Re: Tucson Speedway Historical Houses Relocation
926 N 2nd Ave, Tucson, AZ 85719
CORE Job No. 24-02-006

This correspondence is submitted to document final roof color selections for the subject properties and to request review of limited exterior material and window modifications for House 818 only, as discussed during our on-site walk conducted on January 22, 2026.

818 - FLOOR PLANS
AND SCHEDULES

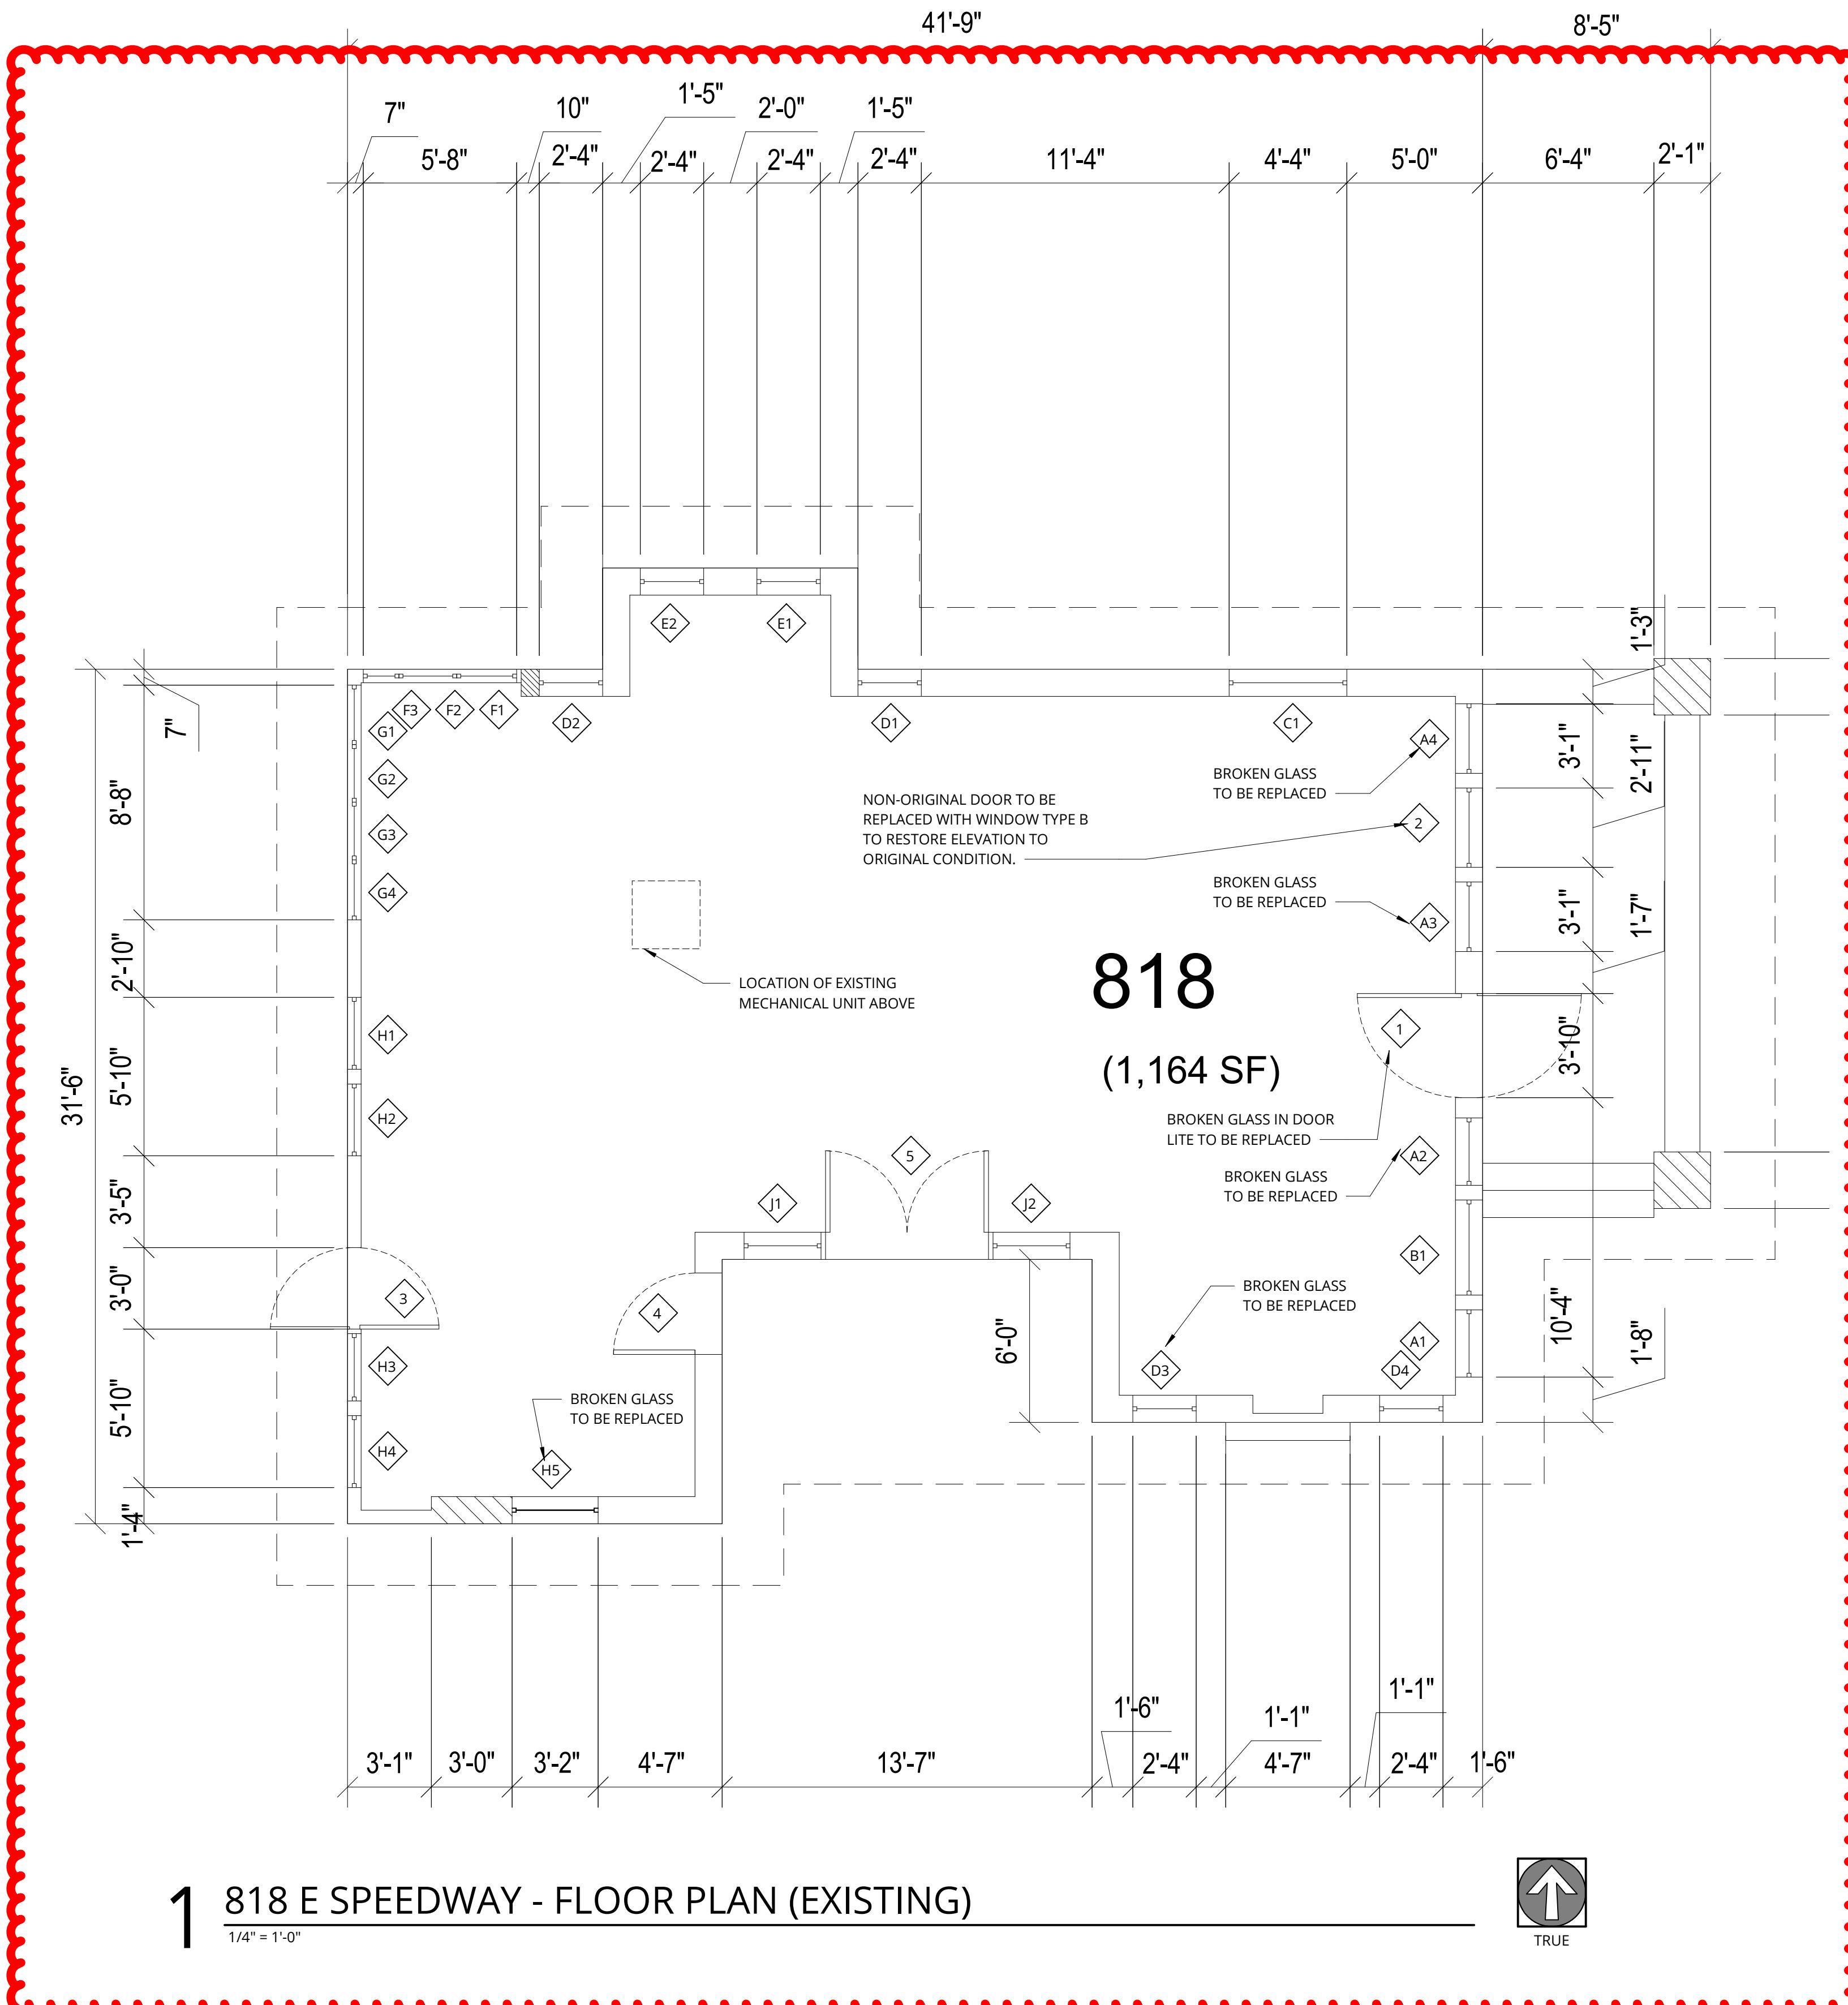
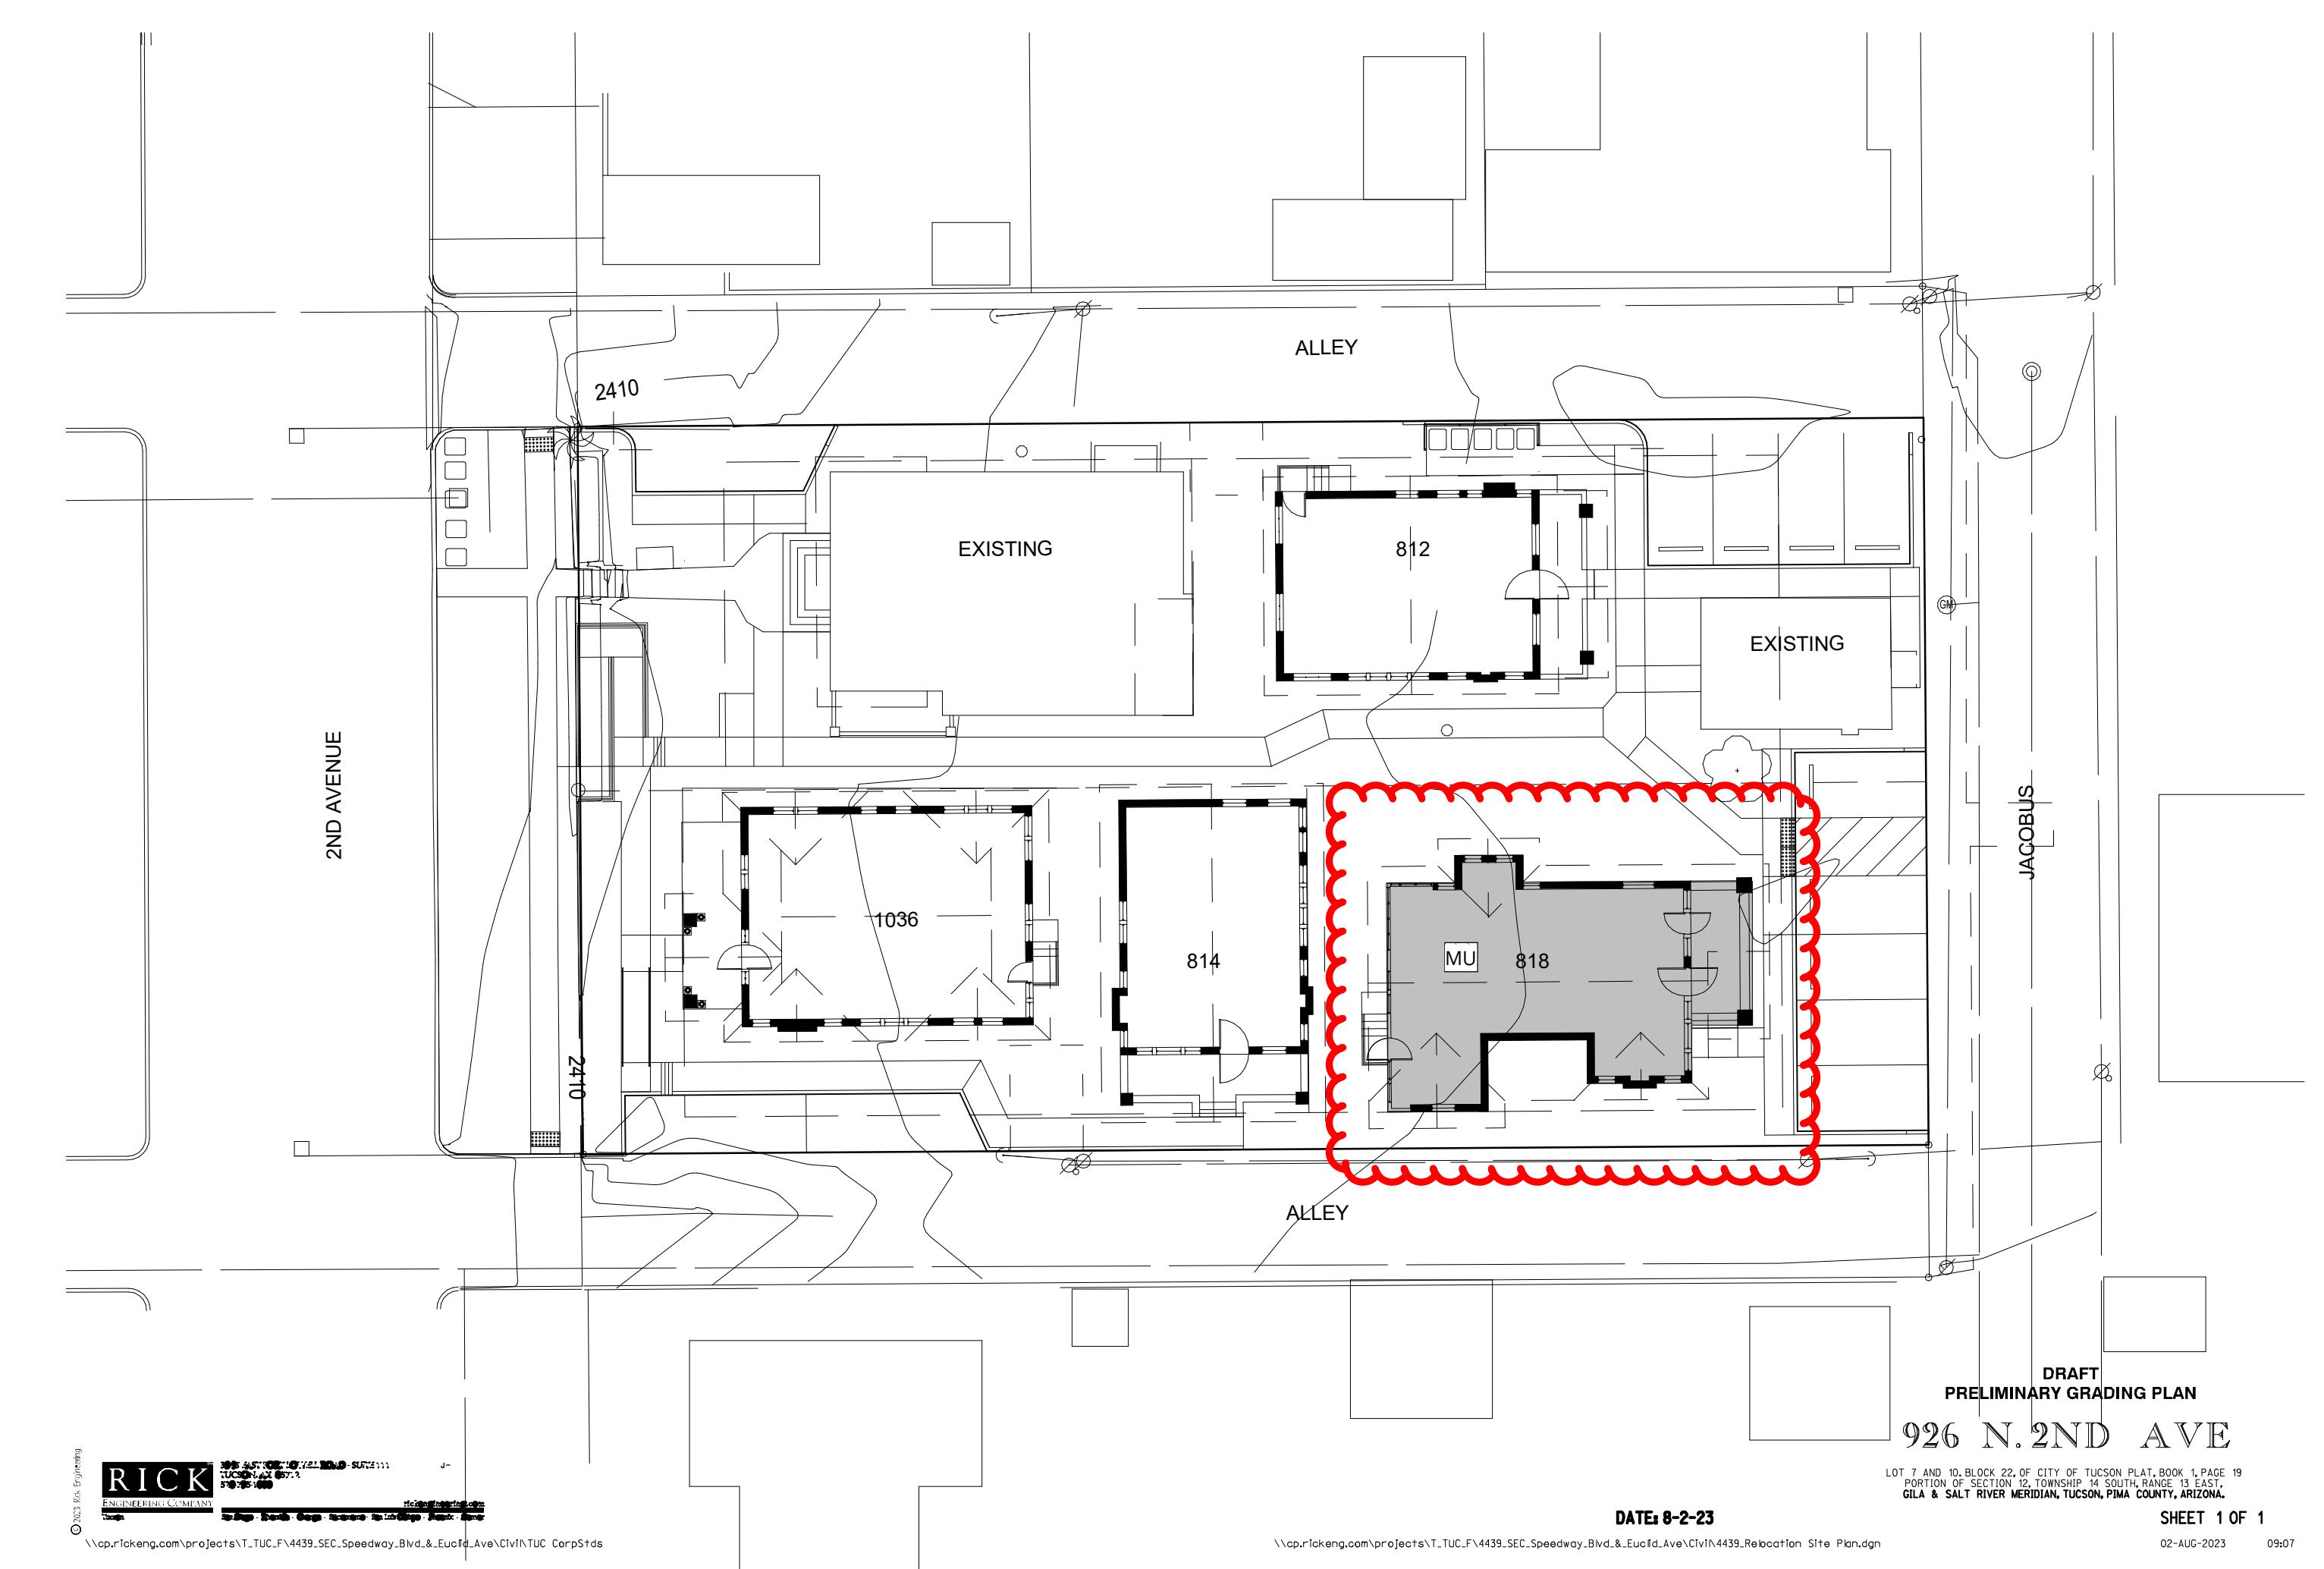
Per the January 22, 2026 site walk, portions of the north elevation, a small section of the south elevation, and the west elevation of House 818 were originally shown to retain existing wood siding. Based on site observations, the existing wood siding in these areas was determined to be not salvageable due to severe water damage. As discussed onsite, these areas are proposed to be replaced with stucco to match the existing house, in order to maintain consistency and improve long-term durability.

As shown on the markup drawings, a revised window configuration is also proposed for House 818 to reflect the layout discussed during the site walk, while maintaining appropriate proportions and alignment consistent with the building's character.

Additionally, as shown on the markup drawings, the east elevation will remain unchanged. It was determined during the site walk that the second entry door on the east elevation is original, and therefore both entry doors are proposed to remain, with the original door to be repaired and restored. These requested changes are limited solely to House 818. No other properties or exterior elements are impacted beyond what is described herein.

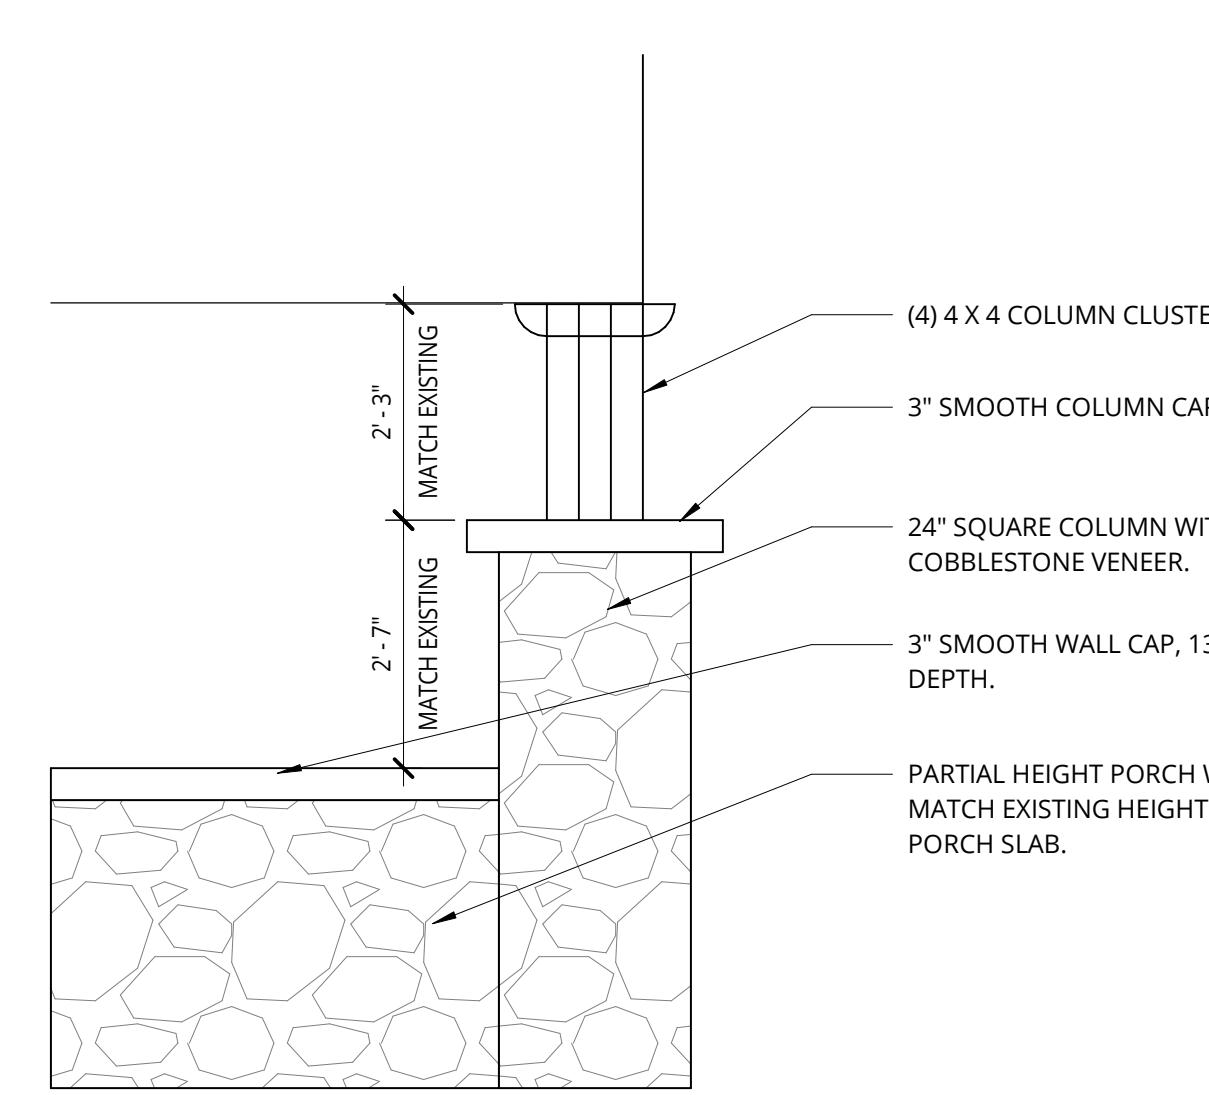
PER OUR ONSITE MEETING, THIS DOOR TO REMAIN IN PLACE. REPAIR AND REPAINT.

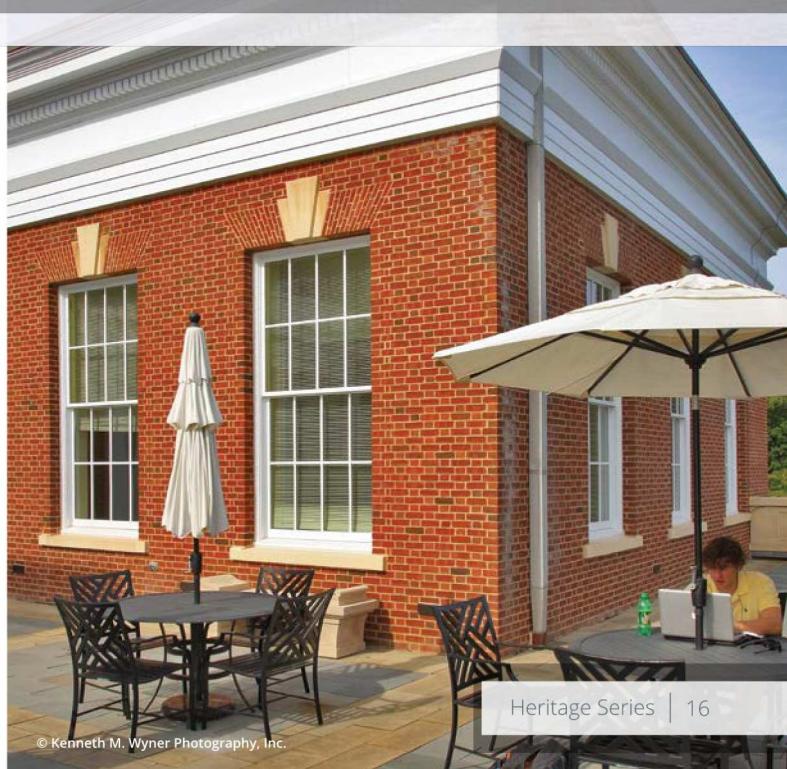
PROPOSED WINDOW REPLACEMENT FOR NORTH AND WEST ELEVATION.
THIS IN LINE WITH COMMENT LEGEND #5 ON THE APPROVED PLANS SHEET
A2.04, REFERENCE BELOW-

5 ANY NEW OR REPLACEMENT WINDOWS TO BE KOLBE HERITAGE SERIES OR APPROVED EQUAL.

MATCH EXISTING SIZE, OPERATION, DETAIL, AND COLORING
